DONALD C. COOK NUCLEAR PLANT, UNIT NO. 2

AMENDMENT TO FACILITY OPERATING LICENSE

Amendment No. 147
License No. DPR-74

SAFETY EVALUATION BY THE OFFICE OF NUCLEAR REACTOR REGULATION
RELATED TO AMENDMENT NO. 163 TO FACILITY OPERATING LICENSE NO. DPR-58
AND AMENDMENT NO. 147 TO FACILITY OPERATING LICENSE NO. DPR-74

FIGURE 5.6-1
 DONALD C. COOK NUCLEAR PLANT
 SCHEMATIC FOR SFP INTERFACE BOUNDARY BETWEEN REGIONS 1 AND 2

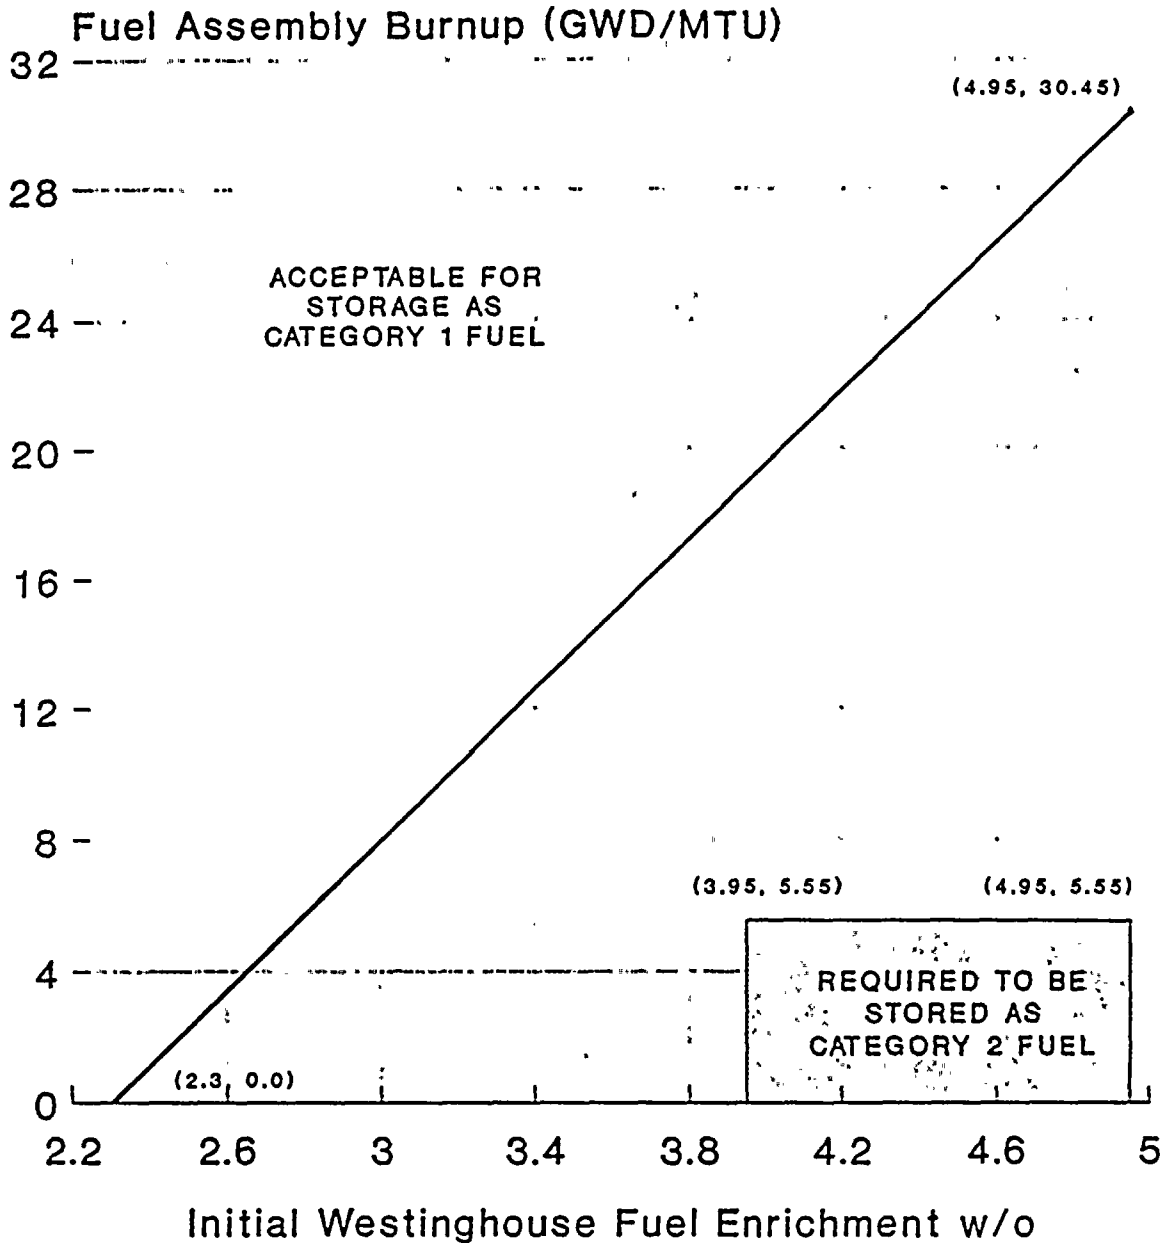
- a. A K_{eff} equivalent to less than 0.95 when flooded with unborated water,
- b. A nominal 10.5-inch center-to-center distance between fuel assemblies, placed in the storage racks.
- c. 1. A separate region within the spent fuel storage racks (defined as Region 1) shall be established for storage of Westinghouse fuel types of enrichment greater than 3.95 weight percent U-235 and burnup less than 5,550 MWD/MTU in a checkerboard pattern configuration alternating Category 1 fuel and Category 2 fuel as shown in Figure 5.6-1.

2. A separate region within the spent fuel storage racks, defined as Region 2, shall be established for storage of Westinghouse fuel of an enrichment less than or equal to 3.95 weight percent U-235 or an enrichment greater than 3.95 weight percent U-235 but with a burnup greater than or equal to 5,550 MWD/MTU, and Exxon/ANF fuel of an enrichment less than or equal to 4.23 weight percent U-235 for a 17×17 assembly or less than or equal to 3.50 weight percent U-235 for a 15×15 assembly.
3. The boundary between the Regions 1 and 2 mentioned above shall be such that the checkerboard pattern storage requirement of Region 1 shall be carried into Region 2 by at least one row as shown in Figure 5.6-1.

- 1) TS 5.6.1.1.c.1 identifies Region 1 of the spent fuel pool for storage of Westinghouse fuel types with nominal fuel assembly enrichments of 3.95 w/o or greater. Fuel stored in Region 1 must be stored in a checkerboard configuration alternating Westinghouse Category 1 and Category 2 fuel, as shown in TS Figure 5.6-1. Category 1 and Category 2 fuel are defined in TS Figure 5.6-2.

- 2) TS 5.6.1.1.c.2 identifies Region 2 of the spent fuel pool. This Region is for the storage of Westinghouse fuel with an enrichment less than or equal to 3.95 w/o U-235 or with an enrichment greater than 3.95 w/o U-235 but with a burnup greater than or equal to 5,550 MWD/MTU, and ANF fuel of an enrichment less than or equal to 4.23 w/o U-235 for a 17x17 assembly or less than or equal to 3.50 w/o U-235 for a 15x15 assembly.
- 3) TS 5.6.1.1.c.3 addresses the boundary condition between Regions 1 and 2 and requires that the checkerboard pattern for Region 1 must be carried into Region 2 by at least one row. This is illustrated in revised TS Figure 5.6-1.
